# TERRA RIDGE NORTH CIVIL CONSTRUCTION PLANS El Paso County, Colorado

INDEX OF SHEETS	
SHEET NUMBER	SHEET DESCRIPTION
C1	COVER
C2	NOTES
C3	GENERAL NOTES AND ROADWAY SECTIONS
C4	ROADWAY KEY MAP SHEET
C5	PLAN AND PROFILE
C6	STORM PLAN AND PROFILE
C7	DETENTION POND STRUCTURE AND EMERGENCY OVERFLOW SECTION

EL PASO COUNTY DEVELOPMENT  
REPLAT TERRA RIDGE LOTS 5 & 6 W/ 11 LOTS IN  
TERRA RIDGE NORTH  
COVER SHEET

C-3 CAST IN PLACE FOREBAY PLAN AND SECTION DETAILS  
NTS

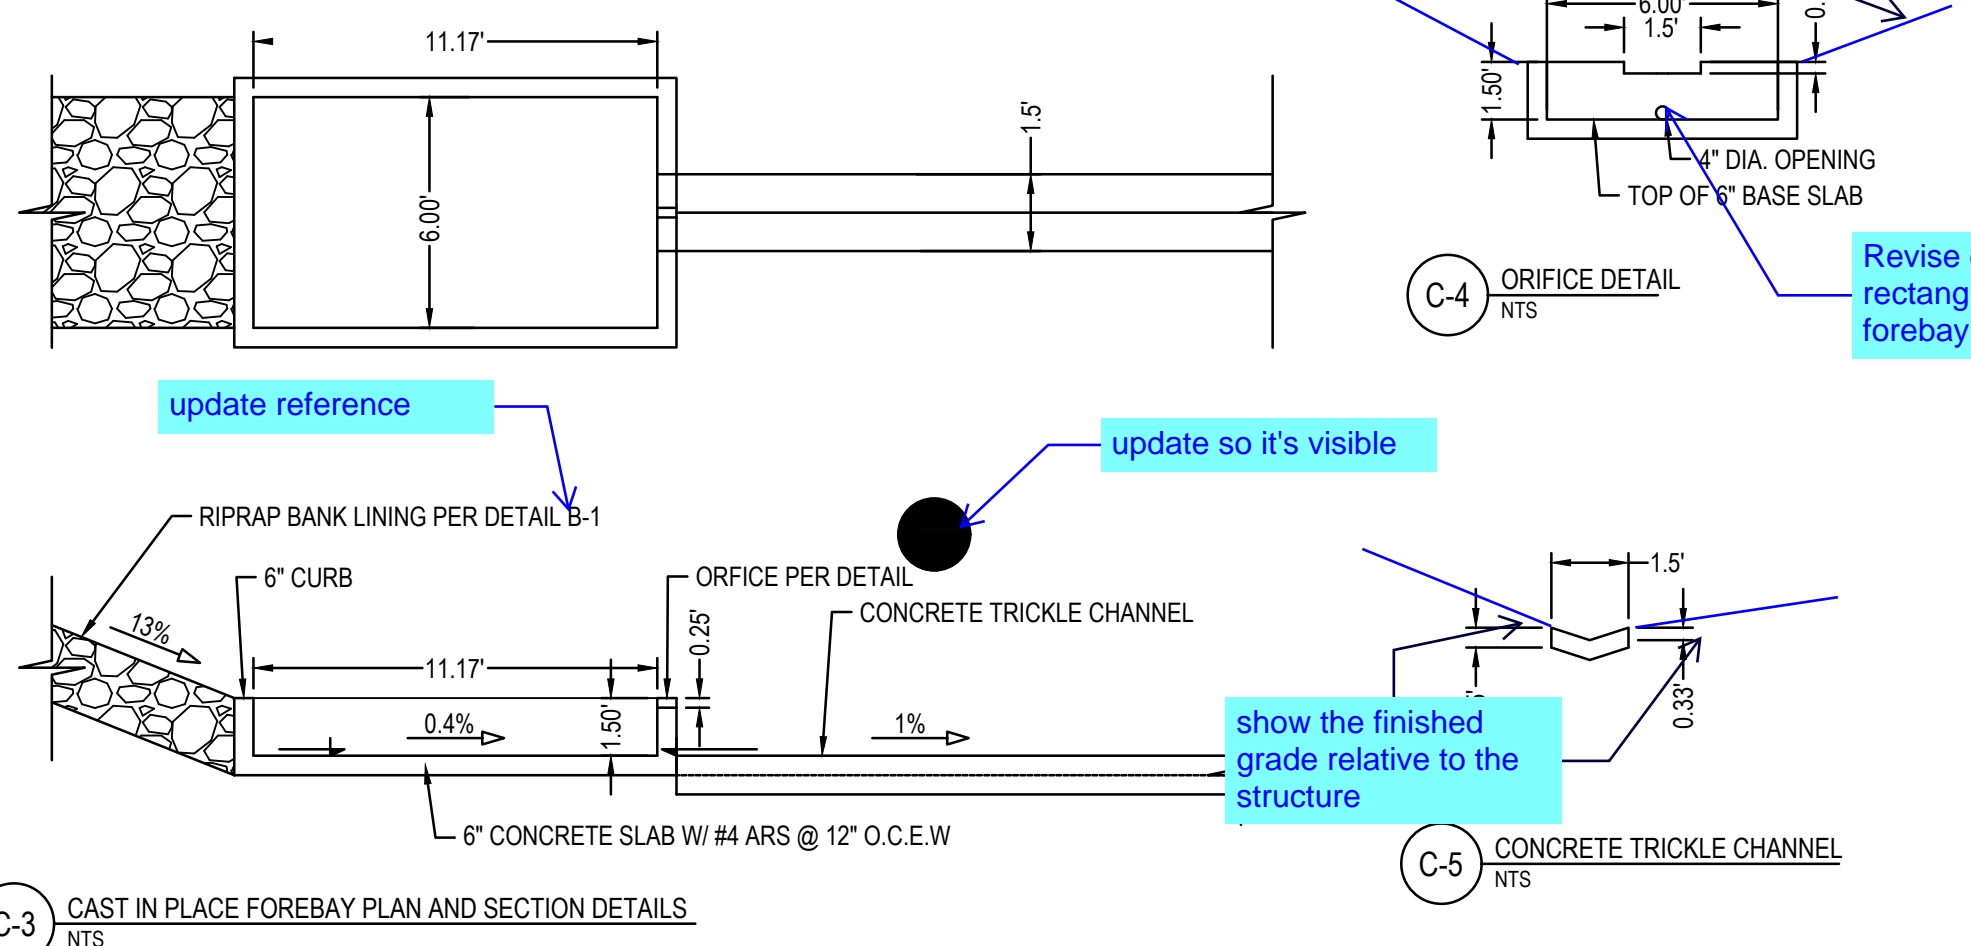
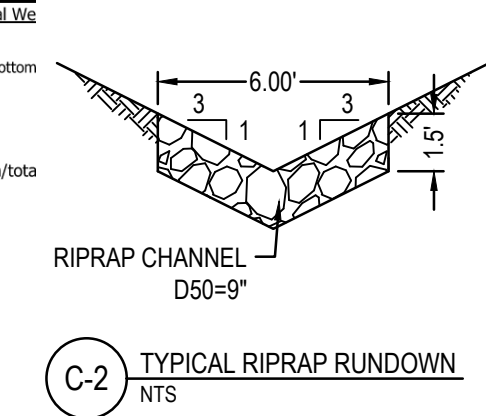
Revise design to a rectangular notch for forebay walls

show the finished grade relative to the structure

C-8 OUTLET STRUCTURE CROSS SECTION  
SCALE 1"=3'

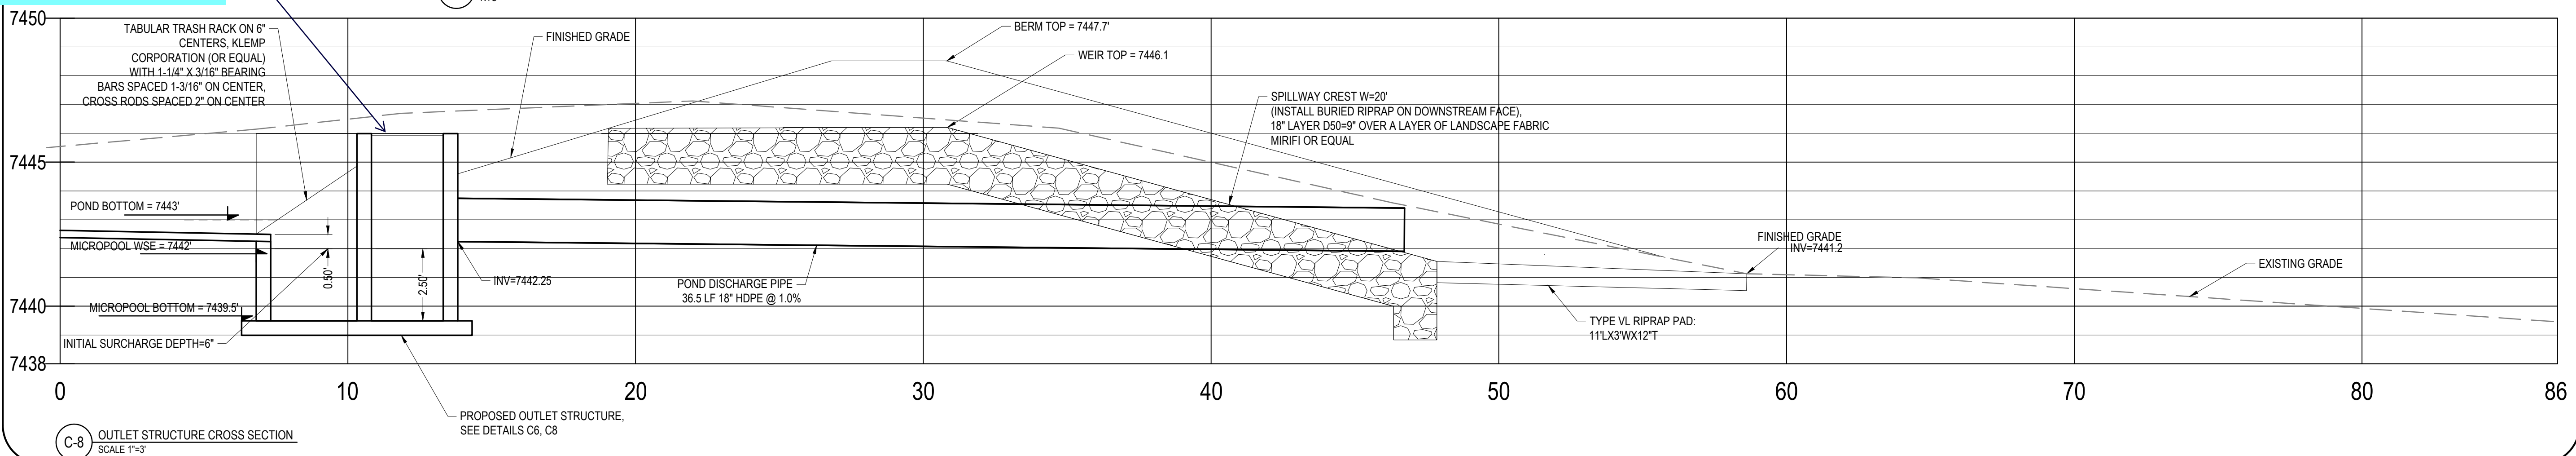
update structure profile to match detail and drainage report. MHFD-Detention noted 4:1 slope, not horizontal for the second chamber
